TOWN OF MILTON
PLANNING AND DEVELOPMENT
JUNIPER 6 MODEL

BUILDING: REVIEWED
SCOTT SHERRIFFS APR 13, 2017
PLANS EXAMINER DATE

JUNIPER 6
ENERGY STAR

PROJECT NAME
LECCO RIDGE

PARTIAL BASEMENT PLAN FOR WALK-UP CONDITION

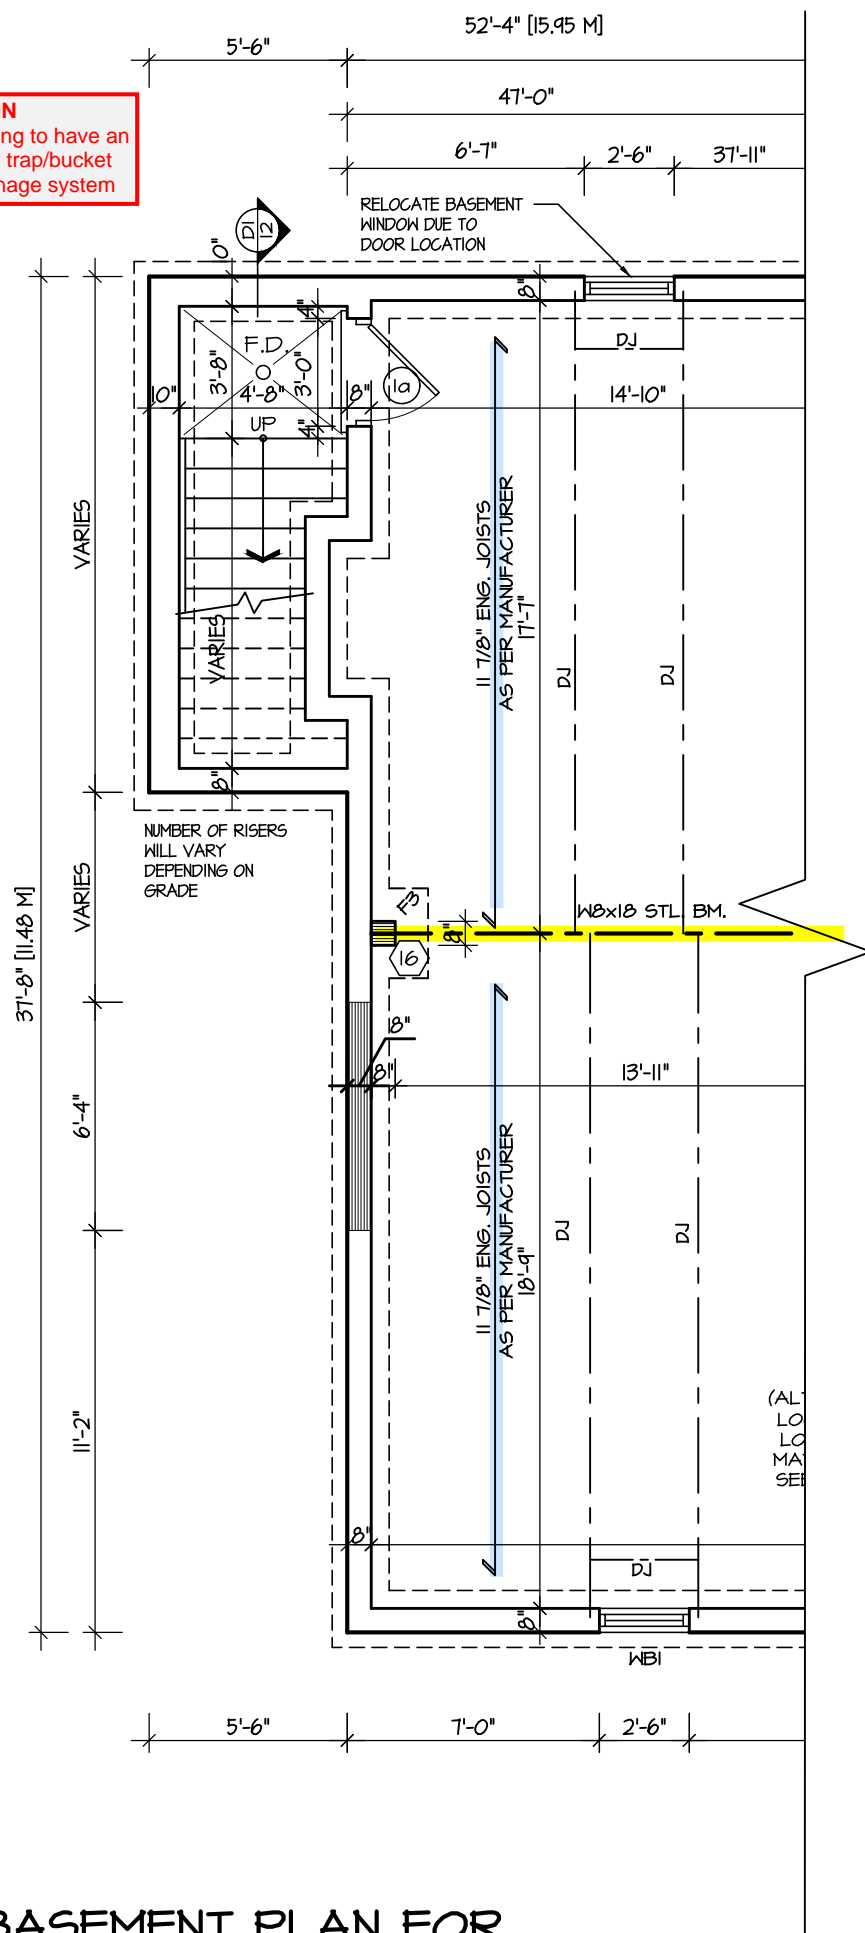
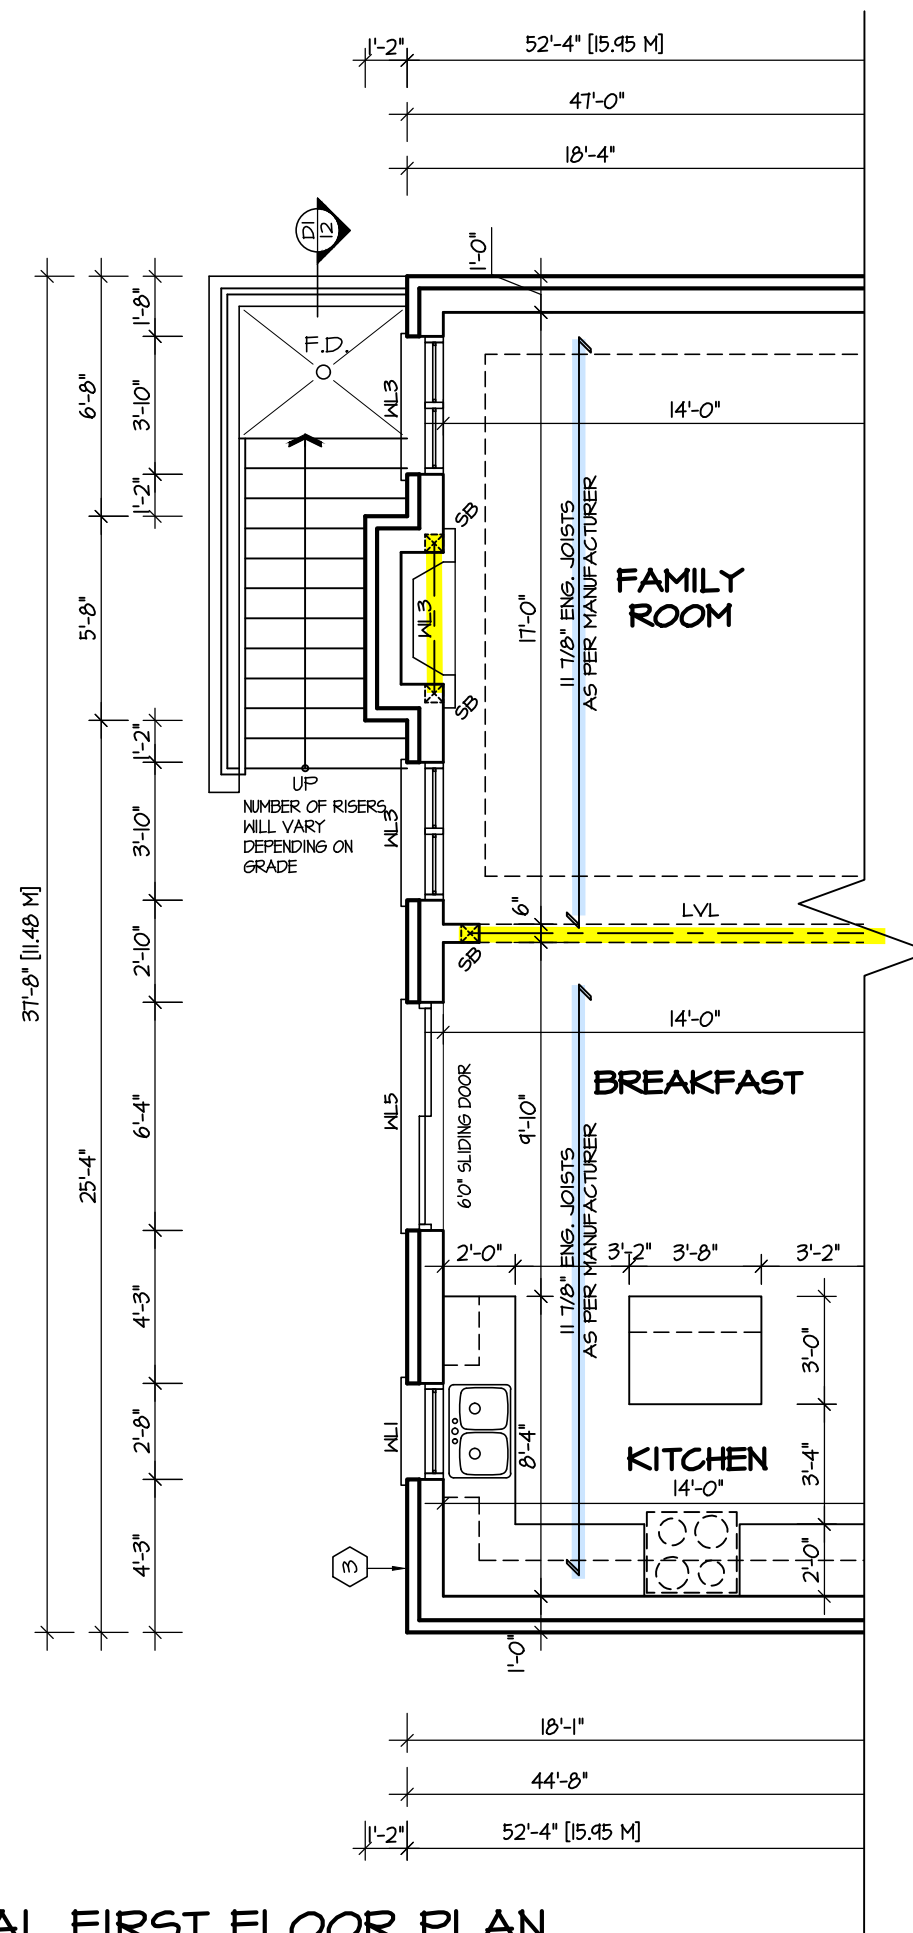
WALKOUT AREA DRAIN
Uncovered walkout landing to have an area drain with sediment trap/bucket connected to Storm drainage system

WALKOUT BSMT. INSULATION
See standard details page 12 for required perimeter slab insulation for walkout basement condition
